Basin Pump Station Improvements Phase II Project  
SAWS Job No. 15-6004  
Solicitation No. CO-00163

**ADDENDUM No. 2**

March 30, 2018

**G-006**

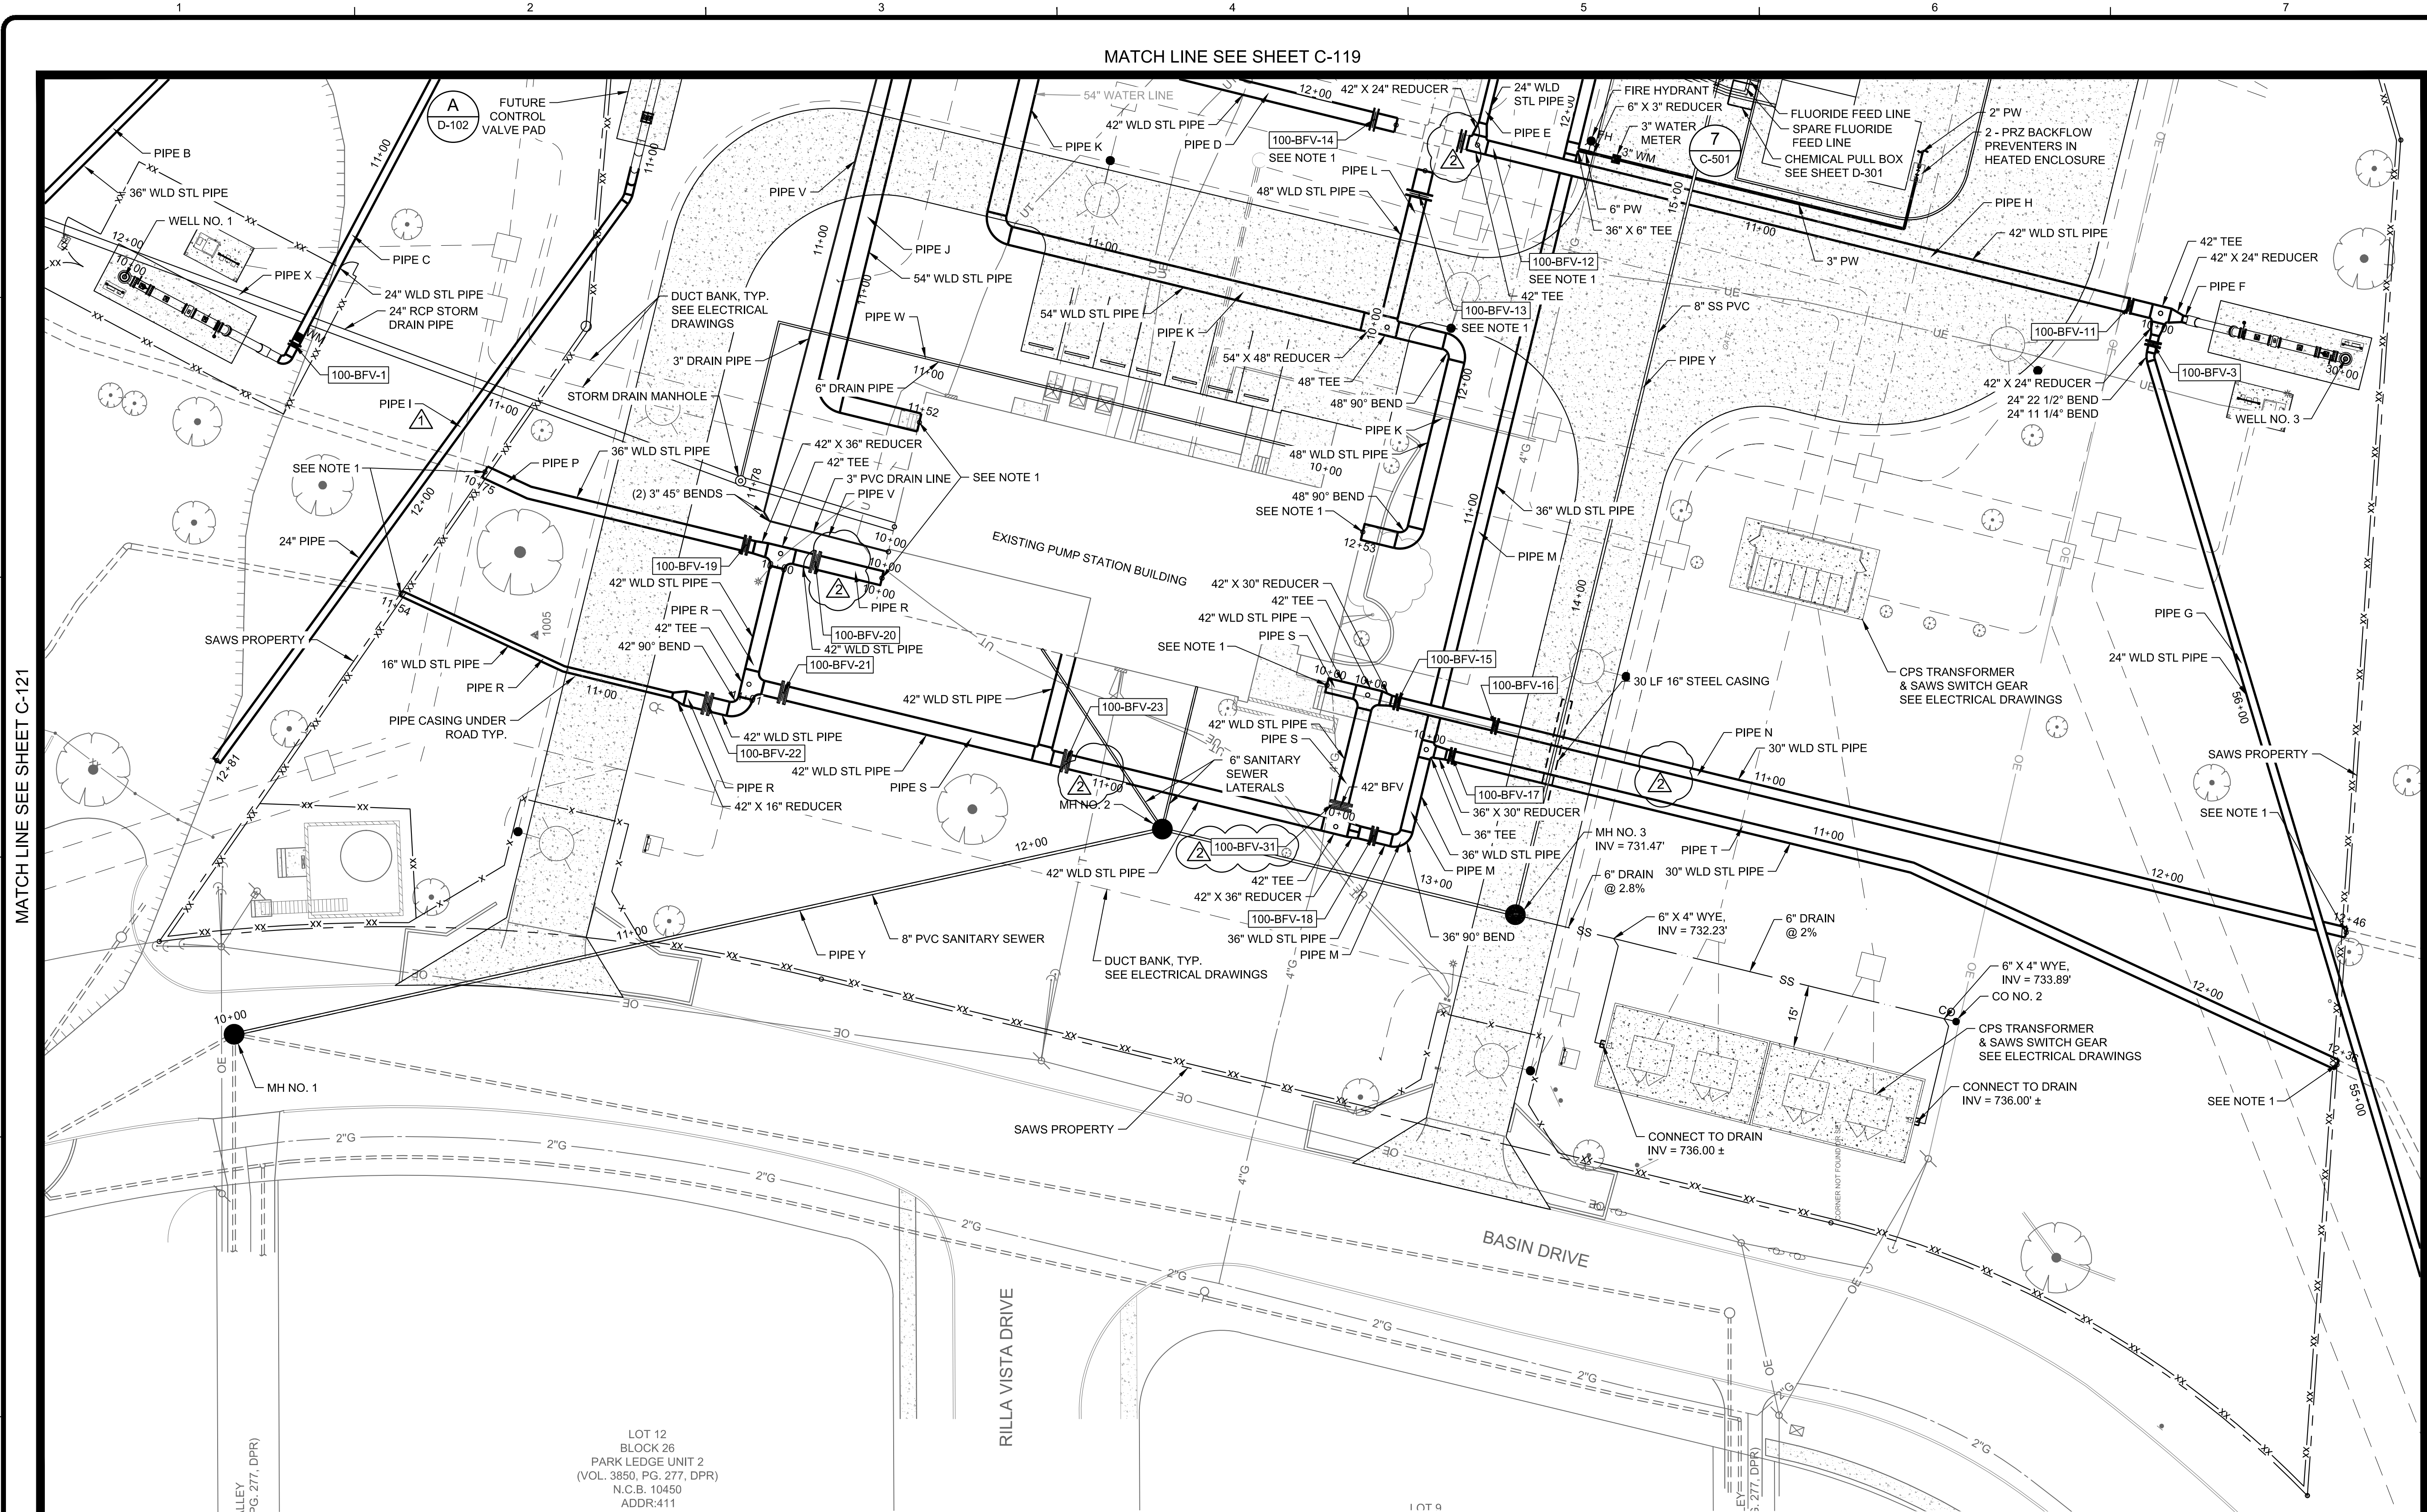
- 1.12.** Section 11366 2.01.4 mentions a total of 8 Hydrogen Dilution Blowers, drawing G-005 only shows a total of 4 blowers. Please confirm amount of Hydrogen Dilution Blowers for OSHG system.

**Response:** Refer to the revised Sheet G-006, attached herein, for blowers BLO-5 through BLO-8. A total of 8 blowers will be provided.

C-120

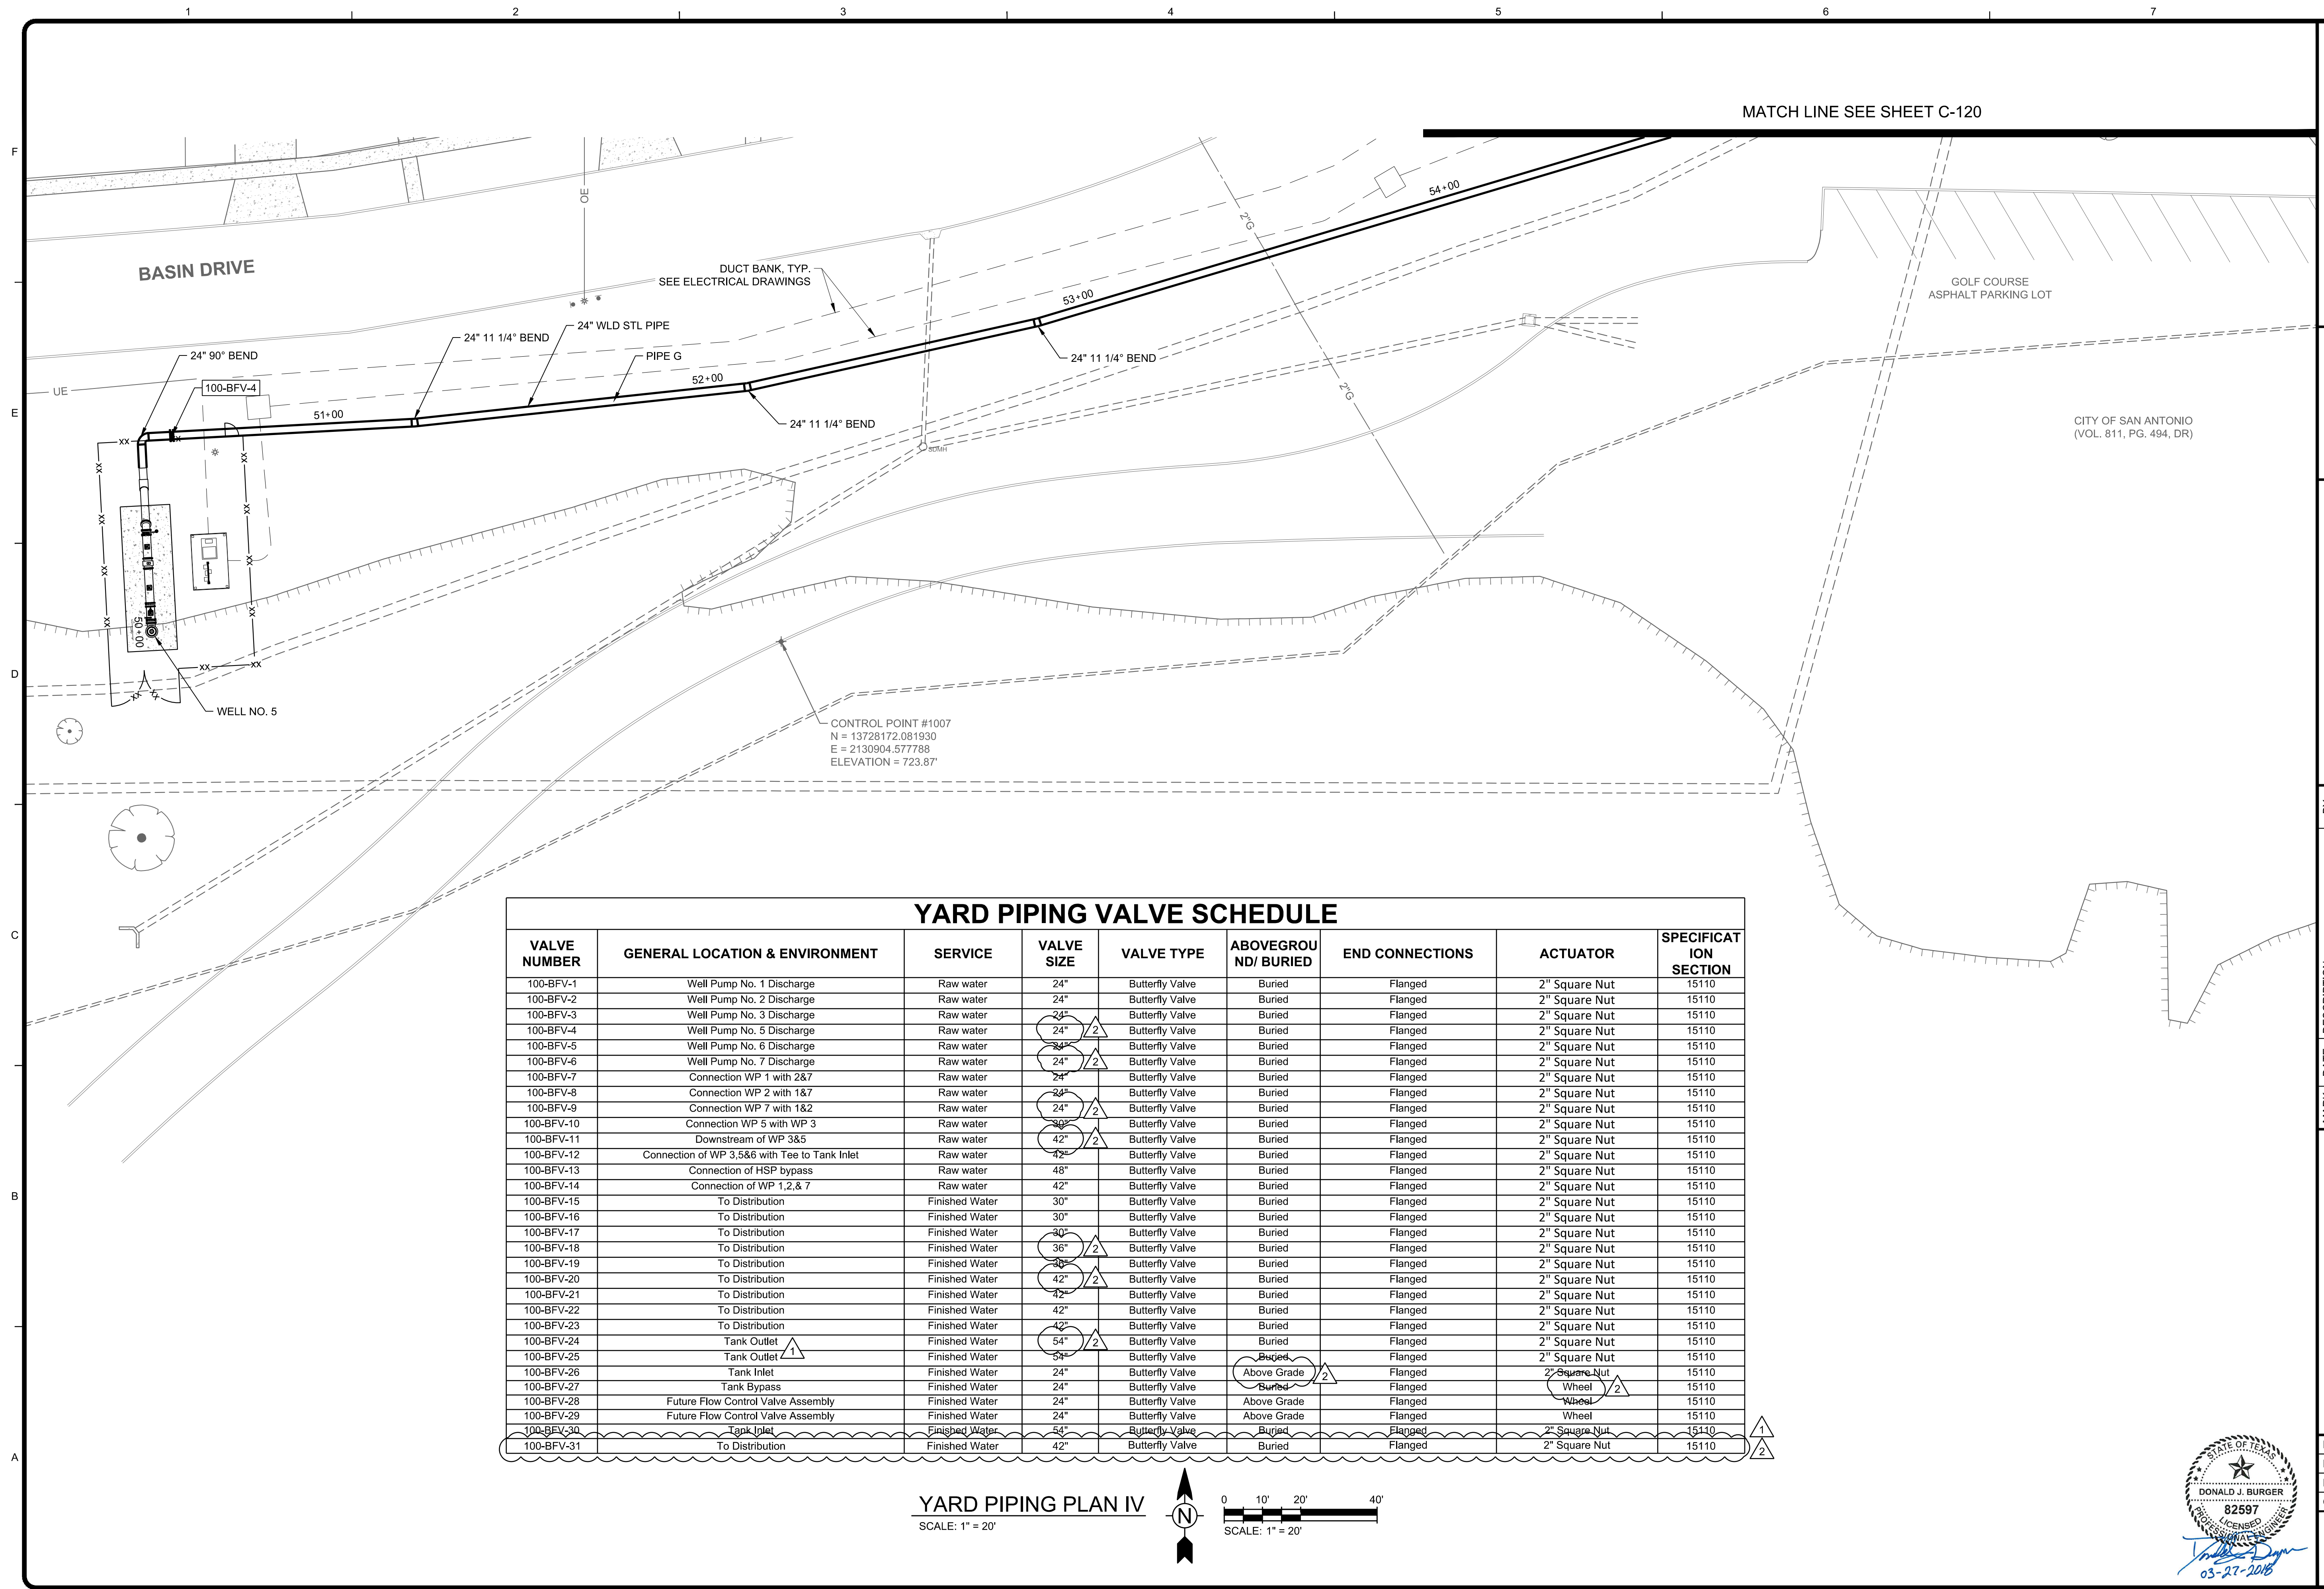
- 1.29.** On Drawing C-120 Water Lines N, R and S indicate water meters (WM). These lines are 42" and 30" sizes. What type of water meter are these, and would they be inside a vault? The only water meter details are for 4" and 3" sizes.

- 1.30.** The profile for 30" Water Line N (C-127) indicates three (3) butterfly valves within approximately 80 ft of pipe. This line on Drawing C-120 shows 100-BFV-15 and 100-BFV-16 and a water meter. On this drawing there are also water meters (WM) indicated on 42" Water Lines R and S, but the meters are not shown in their respective profiles on Drawing C-128.

**Response:** Water meter located on Pipe N, Pipe S, and Pipe R are not required. Refer to part 3, Modifications to the Drawings, Item 3.3 herein.

**Response:** Water meter located on Pipe N, Pipe S, and Pipe R are not required. Refer to part 3, Modifications to the Drawings, Item 3.3 herein.
